Attachment 1
NRC3-13-0015
(191 pages)

FSAR Markups

The following markup represents how DTE Electric intends to reflect this RAI response in the next submittal of the Fermi 3 COLA. However, the same COLA content may be impacted by responses to other COLA RAIs, other COLA changes, plant design changes, editorial or typographical corrections, etc. As a result, the final COLA content that appears in a future submittal may be different than presented here.

Figure 2.0-201

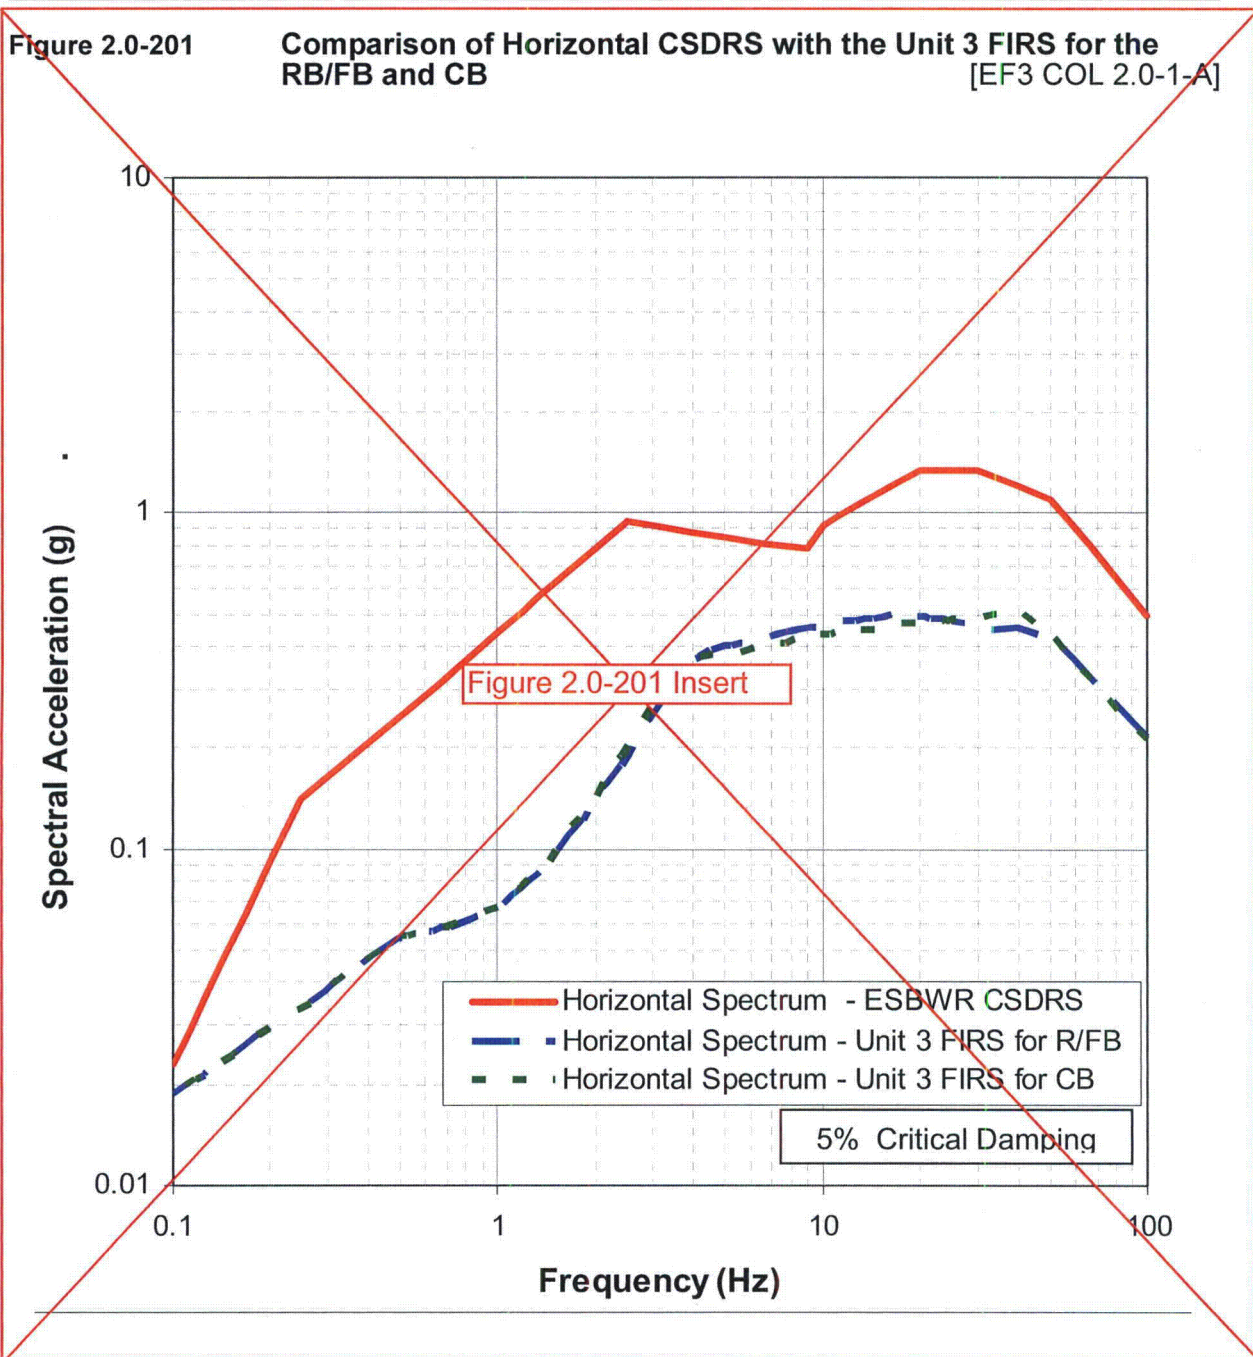
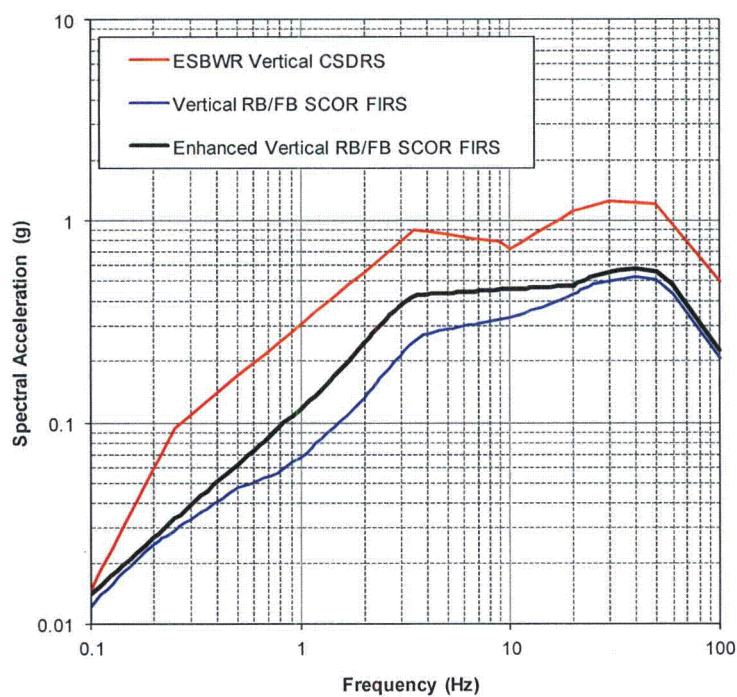
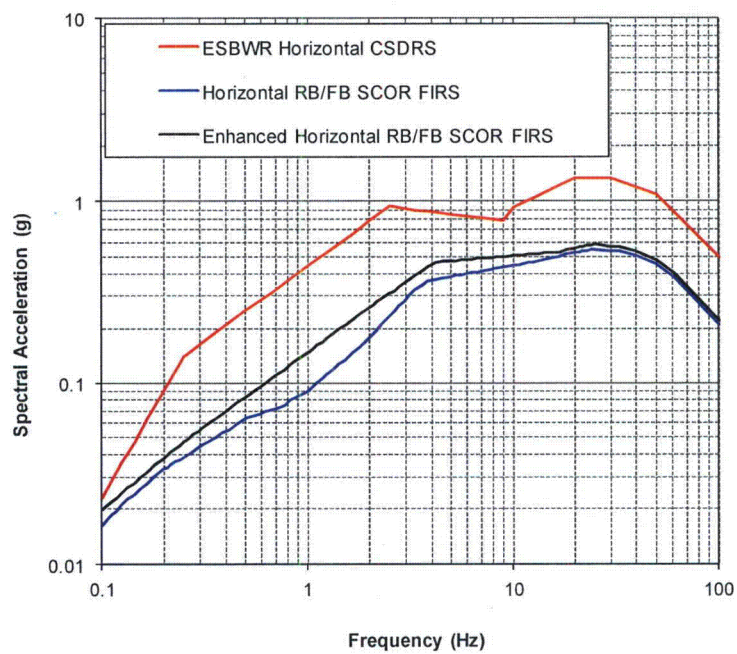
Figure 2.0-201 Insert

Figure 2.0-201 Horizontal and Vertical RB/FB Enhanced SCOR FIRS and CSDRS [5 Percent Damping]
(FIRS are developed in Subsection 3.7.1)

Figure 2.0-202

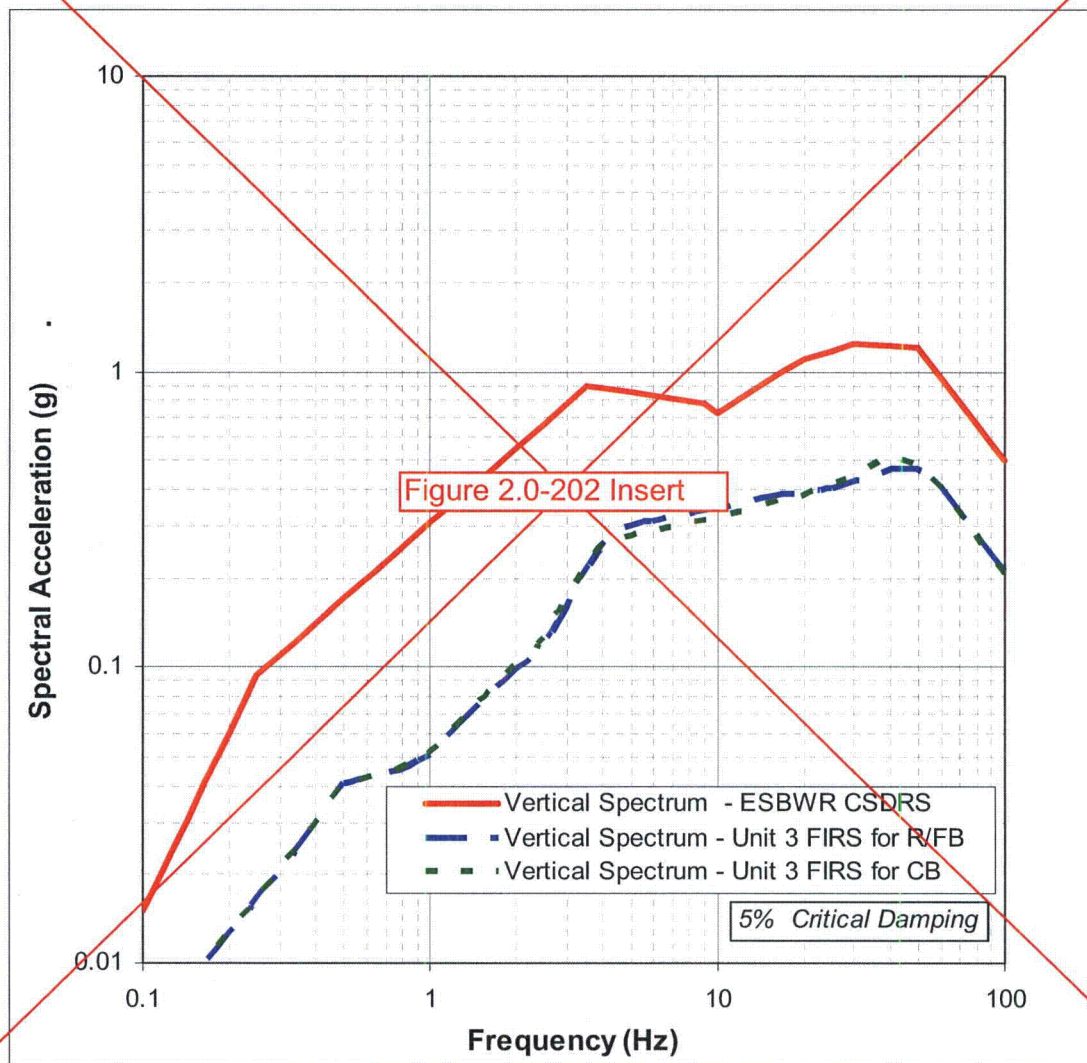
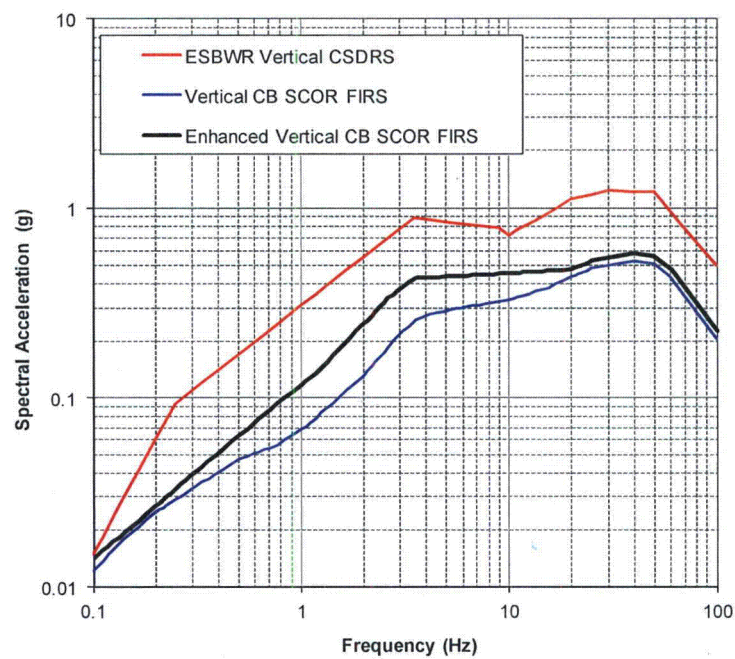
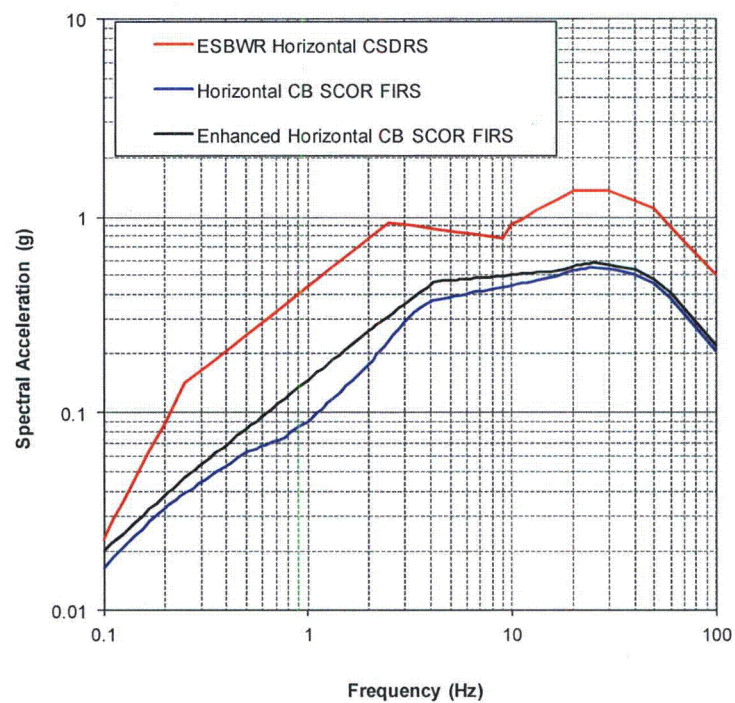
Figure 2.0-202 Insert

Figure 2.0-202 Horizontal and Vertical CB Enhanced SCOR FIRS and CSDRS [5 Percent Damping]
(FIRS are developed in Subsection 3.7.1)

Figure 2.0-203

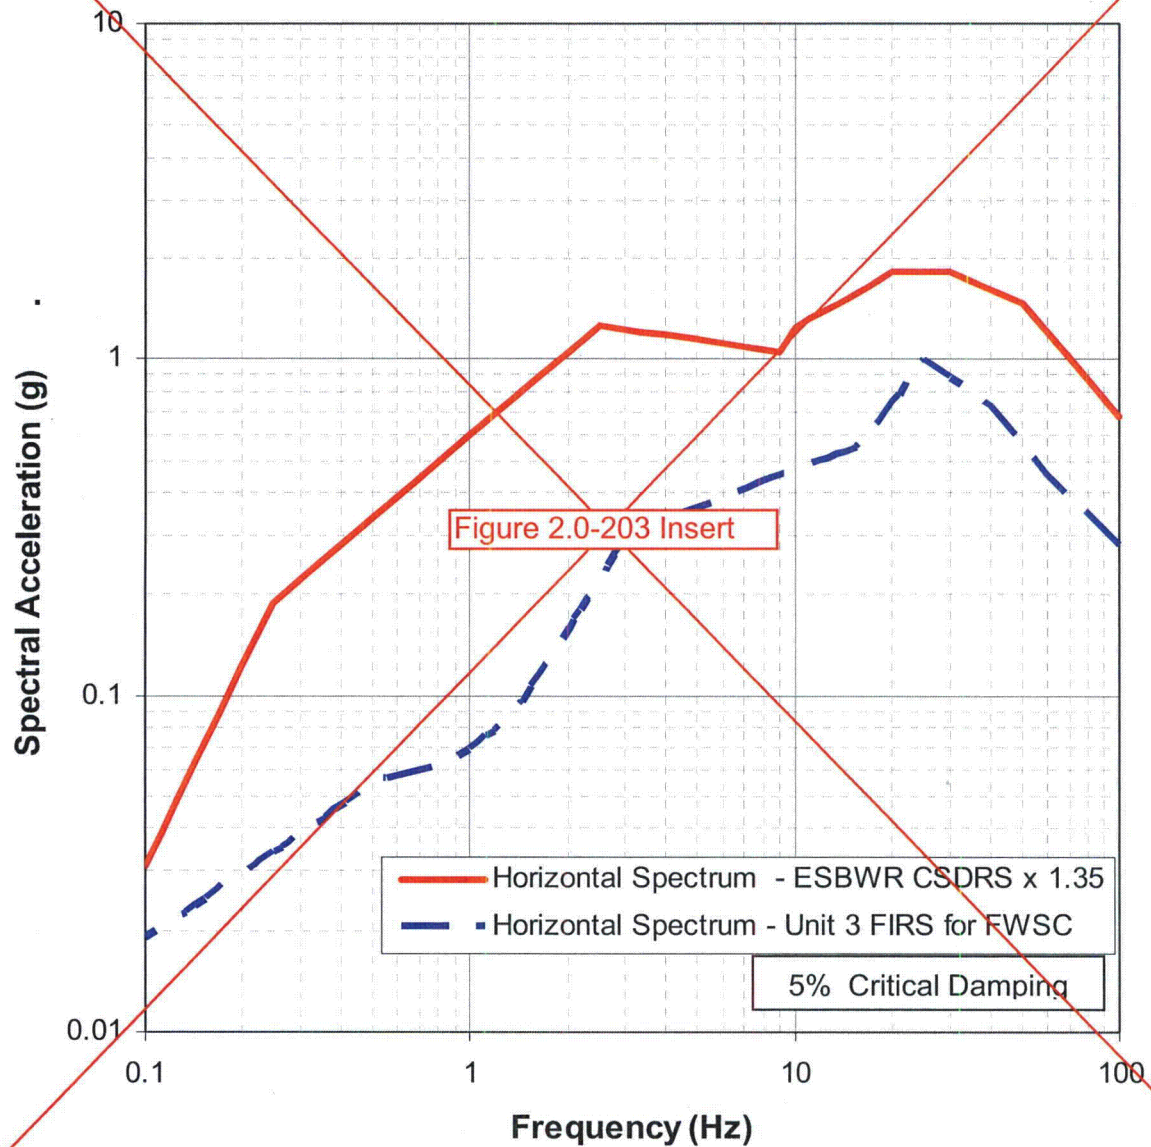
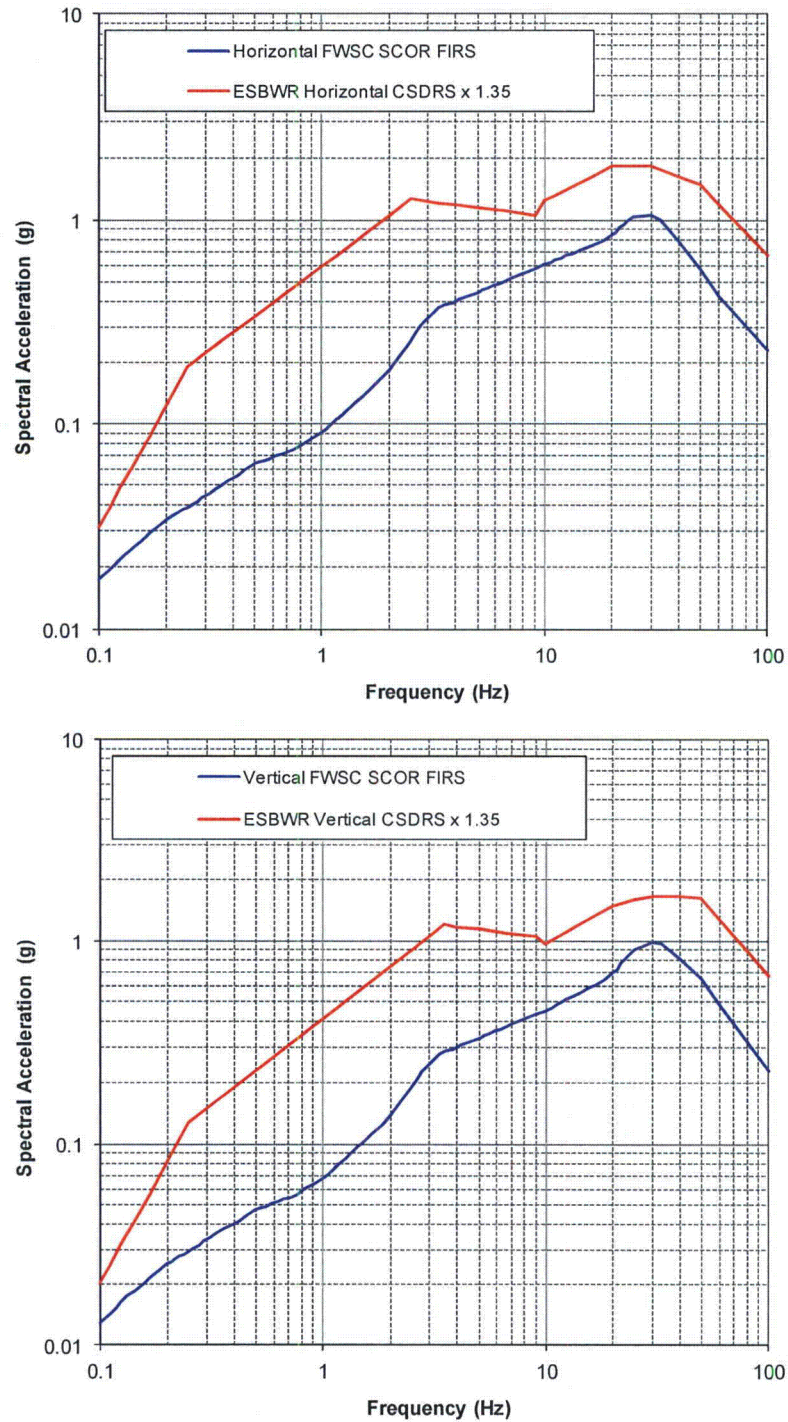
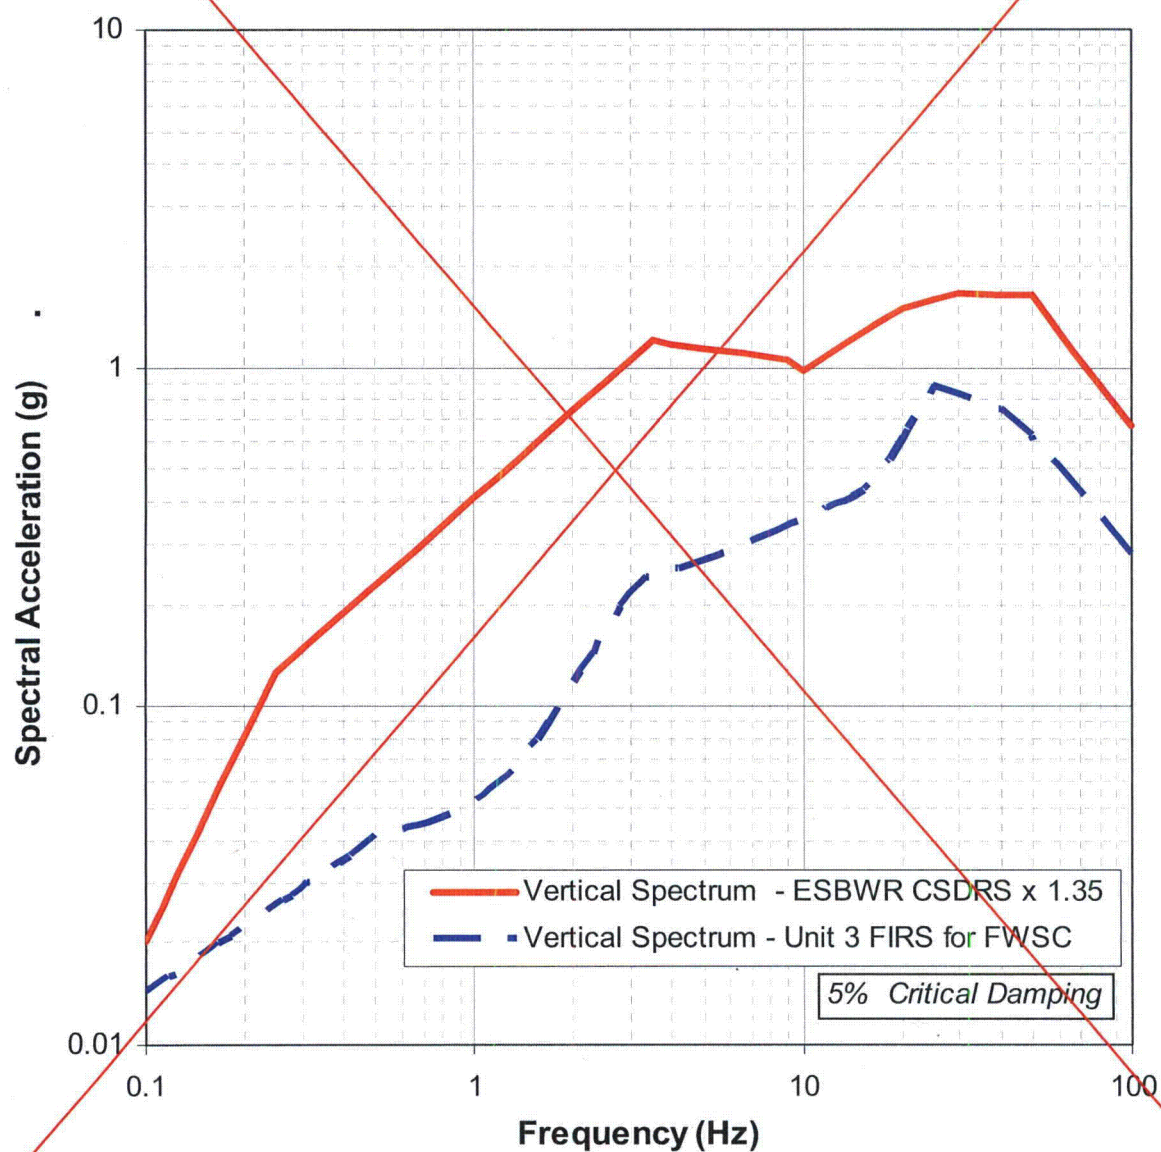
Figure 2.0-203 Insert

Figure 2.0-203 Horizontal and Vertical FWSC FIRS and 1.35 Times the CSDRS [5 Percent Damping] (FIRS are developed in Subsection 3.7.1)
